UNITED STATES PATENT AND TRADEMARK OFFICE

| APPLICATION NO. | FILING DATE | FIRST NAMED INVENTOR | ATTORNEY DOCKET NO. | CONFIRMATION NO. |
|-----------------|-------------|----------------------|---------------------|------------------|
| 10/659,655 | 09/10/2003 | Barry M. Thompson | 6956.07 | 3659 |

Office Action Summary

FIG. 1

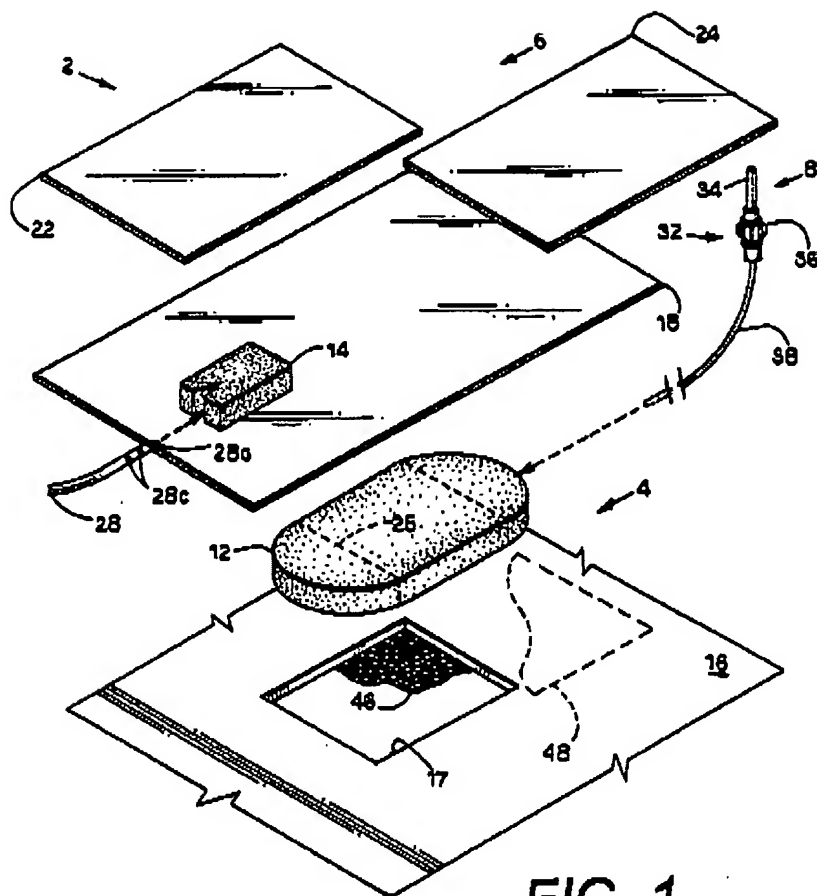
Regarding claim 1, Zamierowski teaches an evacuation apparatus (2) for removing gaseous byproducts or noxious vapors comprising:

a head (18, 22, 24) substantially defining a plenum having an outer surface (22, 24), said plenum having an inner periphery defining a generally central opening (upside down cavity created directly over wound), said plenum having an opening in said outer surface (22, 24) adjacent to the inner periphery (20a, 20b);

a plenum support (12) for preventing the plenum from collapsing when a low pressure is established therein;

a fluid source nozzle (32) adapted to guide a fluid to the head (18, 22, 24); and
a vacuum nozzle (28) adapted to guide a fluid from the head (18, 22, 24)(see figures 1 and 3, below).
